ENHANCING LAST MILE CONNECTIVITY

a safety analysis of the Jhandewalan Metro Station

Jhandewalan

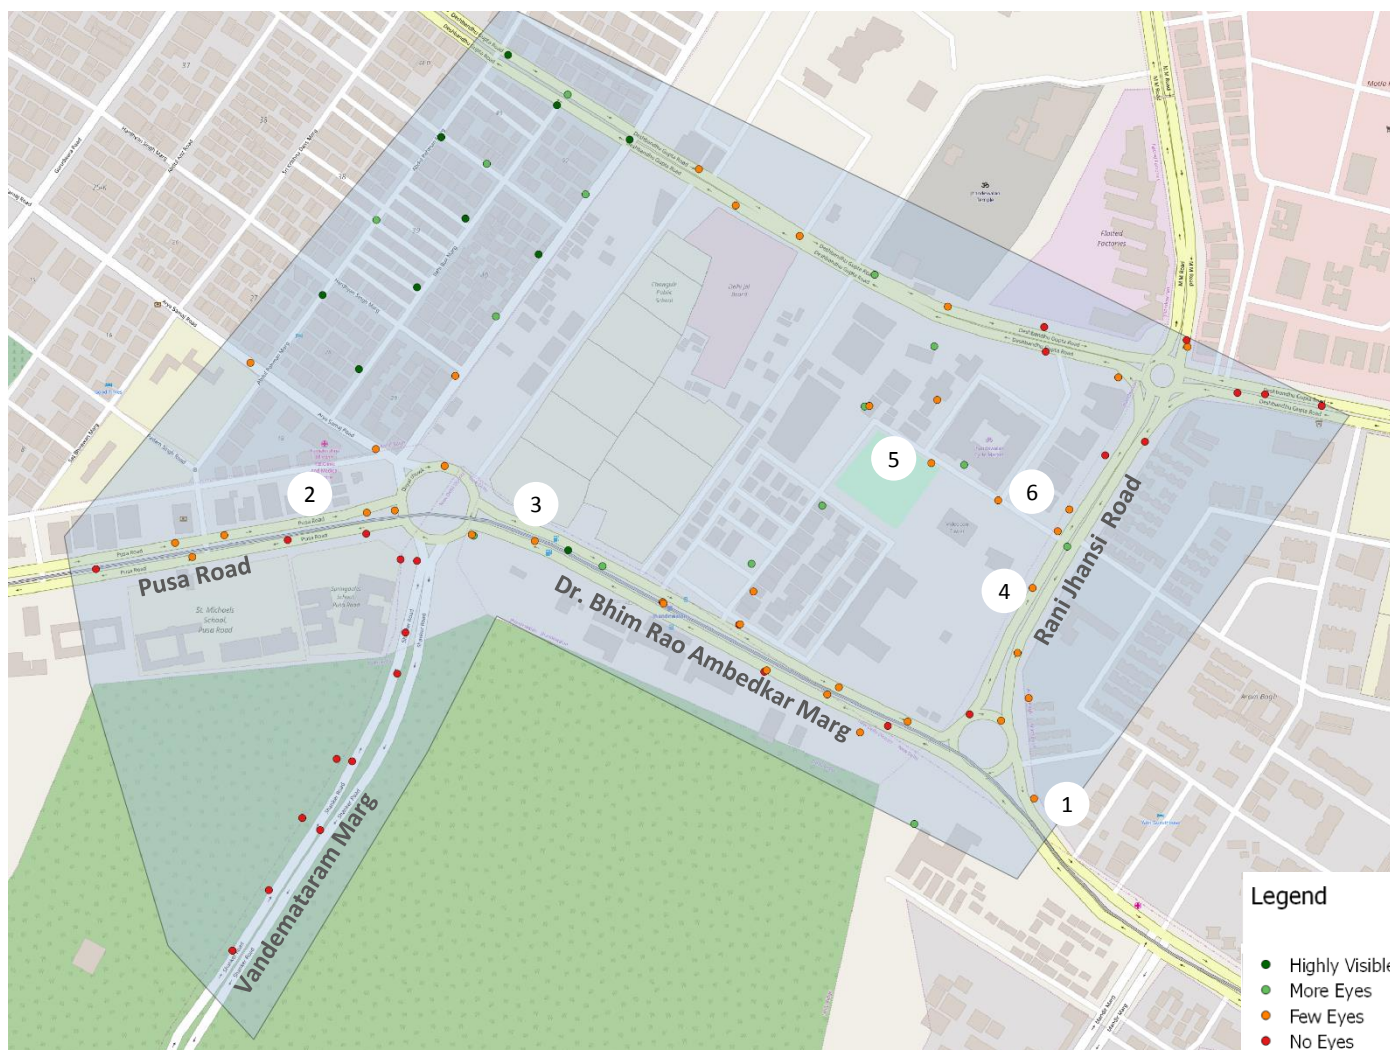
The footpath was found to be damaged at many audit points. The broken and obstructed footpath as seen in Pic 1, 2 and 5 can prove risky for pedestrians. There are no ramps provided for the people on wheelchair. Tactile paving is provided, but it is broken and non-continuous at multiple audit points. Cars are seen parked on the footpath, despite a defined edge (Pic 1). The footpath should be repaired and the tactile paving should be laid again, clear of any obstruction. Also, ramps should be provided for the physically challenged. To avoid vehicular parking on the footpath, designated space should be provided for them.

Seen in Pic 3, a public toilet constructed in between the footpath, obstructs movement of the pedestrians. This public toilet should be shifted, and set up clear of the footpath. Also, the footpath should be repaired to bring it to the same level.

Currently, the kaccha walkpath along Dayal Chowk forces the pedestrians to walk on the main road (Pic 4). A proper footpath should be constructed for the pedestrians. It should also have separate space for the street vendors, clear of the footpath.
